SUBJECT: RECALL R05JN INADVERTENT ENGINE SHUTDOWN

Inadvertent Engine Shutdown

R05JN
RECALL CAMPAIGN

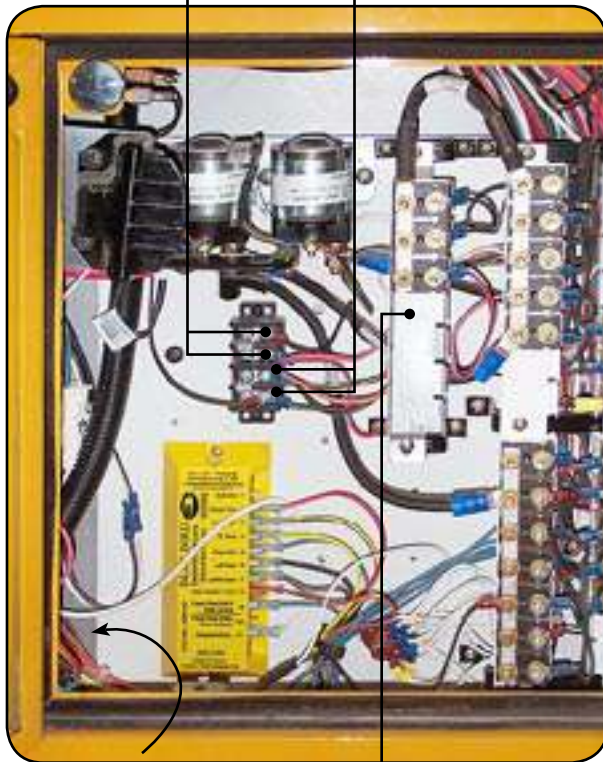
3 Completely remove the wire labeled 1168 as follows:

3.1 Locate the body harness connector block near the lower front corner of the panel. Locate the pink wire with black tracer, labeled 1168.

T/S 1 Terminal Block

The wire numbered 1168 will be entirely removed from the harness and discarded.

All other wires connected to these two terminals will be relocated to a new breaker.

The bottom two terminals of the Terminal Block will not be altered.

The Body Harness Connector affected in this procedure is tucked behind the left bottom corner of the panel door post.

Circuit Breaker Bracket

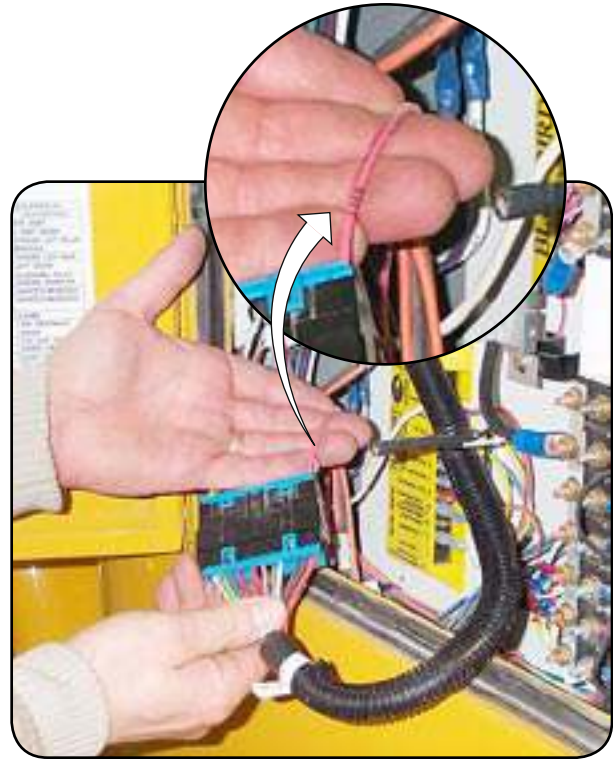
New breaker will be installed here, with relocated accessory wires attached.

3.2 Disconnect the body harness connector. Remove the wire retainer which secures the 1168 wire.

3.3 Using a small screwdriver, mechanic's pick, or other suitable instrument, depress the internal clip which retains the 1168 wire's end terminal. Remove the terminal from the connector block.

Wire 1168 removed from body harness connector.

3.4 Clip the terminal pin off the end of the removed wire. Then pull the wire from the terminal strip end to remove it from the wiring bundle. With the wire completely free, remove its ring terminal from the ignition terminal block and discard the wire.

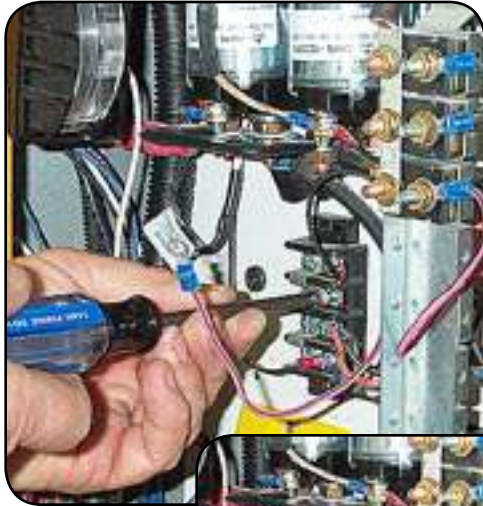
Clip the terminal pin off the removed wire. . .

. . . pull wire out from opposite end. . .

. . . remove from terminal block and discard the wire.

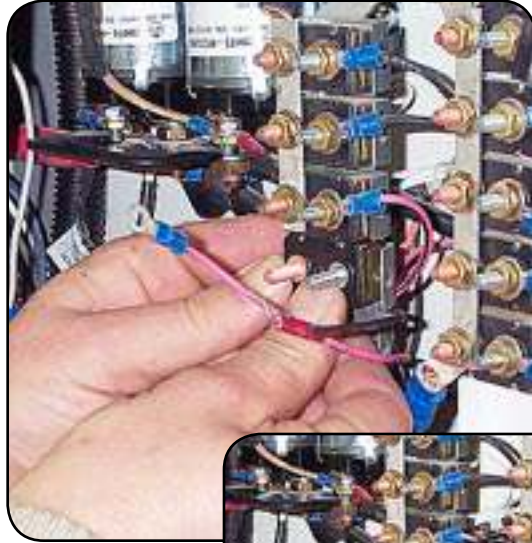
4 On school buses, the two top terminals of the T/S 1 Terminal Block may have additional wires attached, depending upon optional equipment installed. Disconnect any wires from these two terminals and route them behind the Circuit Breaker Bracket as shown:

Remove all wires from the top two terminals...

...and route them behind the Circuit Breaker Bracket.

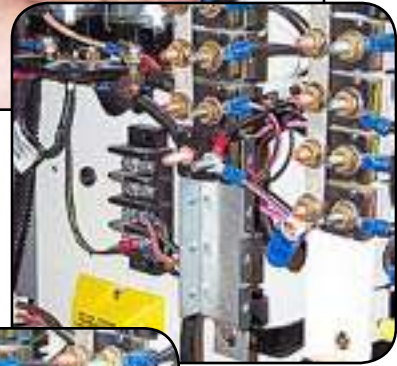
5 Mount a new 15 amp breaker (2006104) in the first available slot of the Circuit Breaker Bracket, with the copper coated stud (labeled "Bat") toward the front of the vehicle. Attach all of the relocated wires from step 4 to the new breaker's silver colored stud (labeled "Aux"):

Install a new 15 amp breaker. Install all wires removed in step 4.

Install plain washer, lock washer, and nut.

Tighten securely with wires spread radially to avoid stacking of the crimped ends.

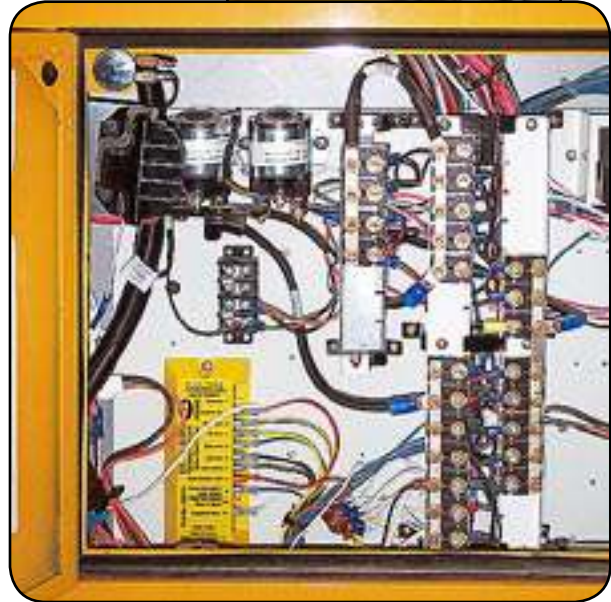
6 Install a new hot bar connector (2006096) to bridge the new breaker with the breaker above it:

Remove nut from left (hot side) terminal of the first breaker above the new breaker.

Install hot connector bar (2006096).

Install plain washer, lock washer, and nut. Tighten securely.

7 Reconnect body harness and place it back in its original position. Close door and reconnect batteries.

Reconnect body harness.

Replace harness connector in original position at lower left of panel.

Finished modification.
